Applicant: Snyder Architects Inc.
Permit Address: 143 Townsend Ave.
Burlington

File: 2314 / 4.4.1 Building Permit

Re: Application # 24 008616
Address: 143 Townsend Avenue
Project Description: Glenview Public School Gym Addition

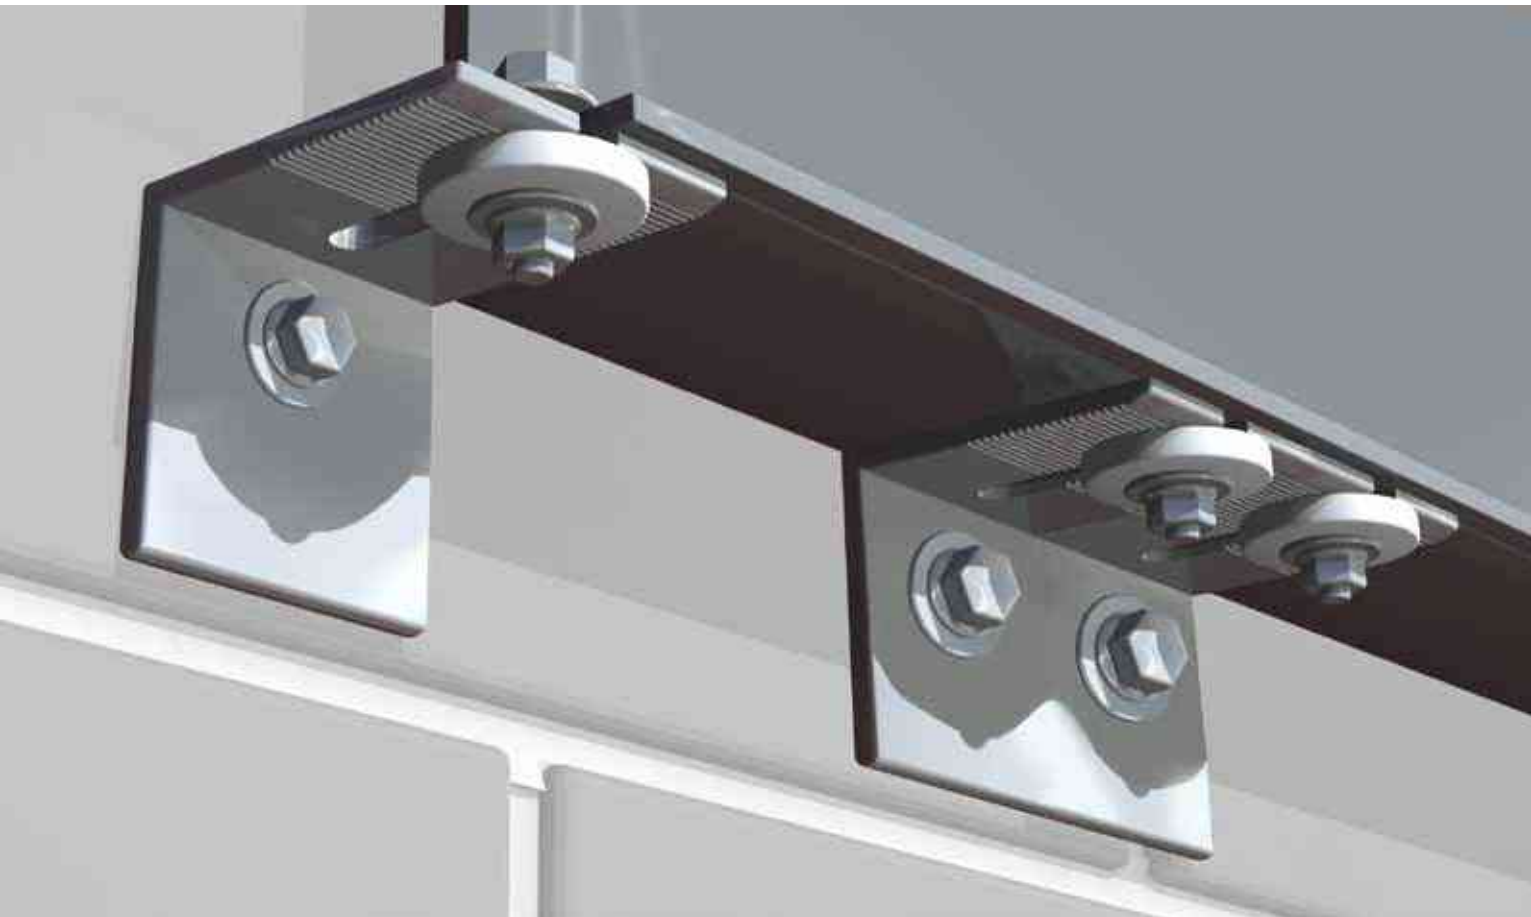
Item 3: Verify how the prevention of fire wall collapse shall be achieved as per Div.B, 3.1.10.1(1)(2) OBC 2012. The structural drawings indicate typical W310X39 beams supporting by fire wall and between grid line 2-3, the Mechanical units having 13.5 KN wt also supported by typical beams and these beams are resting on Fire wall. Please note that there are no two-fire wall provided as per Div.B, 3.1.10.1(2) OBC 2012. The sentence 3.1.10.1(1) requires that the connections and supports of framing members, which are expected to collapse with in fire rated period of fire wall, be detailed such that collapse of framing members will not cause a premature failure of the Fire wall and sentence 3.1.10.1(2) indicates that sentence 3.1.10.1(1) does not apply if Fire wall consists of two separate wall assemblies each tied to its respective building frame but not to each other and designed in such a way that collapse of one wall will not collapse the other . The structural drawings do not show sufficiency of compliance so please review CCMA document as Guideline for Masonry fire wall and NBC commentary C as a guide for these load bearing conditions. Provide structural adequacy of the fire wall as explained above under worst case scenario (at Grid line 2-3) and provide calculation to verify same typical beams are sufficient between even at grid line 2-3 also. Please revise Structural design layout to satisfy all conditions detailed above and coordinate with Architect of record.

Response 3: The prevention of fire wall collapse shall be achieved as per Div.B, 3.1.10.1(1) OBC 2012. The firewall is designed so that the wall will not be compromised in the event of the failure of the structural system. Refer to structural drawings on S1.3, for

firewall connection detail to satisfy sentence Div.B, 3.1.10.1(1) OBC 2012. Please refer to firewall breakaway connection detail. In addition to resisting normal lateral loads as described in Part 4, the wall has been designed to resist a lateral load of 0.5 kPa under fire condition in accordance with article 4.1.5.17.(1)(2) of Part 4 of the National Building Code 2010 (NBCC-10).

Refer to structural drawings on S1.3, for firewall connection detail to satisfy sentence Div.B, 3.1.10.1(1) OBC 2012. Please refer to firewall breakaway connection detail. In addition to resisting normal lateral loads as described in Part 4, the wall has been designed to resist a lateral load of 0.5 kPa under fire condition in accordance with article 4.1.5.17.(1)(2) of Part 4 of the National Building Code 2010 (NBCC-10) and NBC Commentary C.
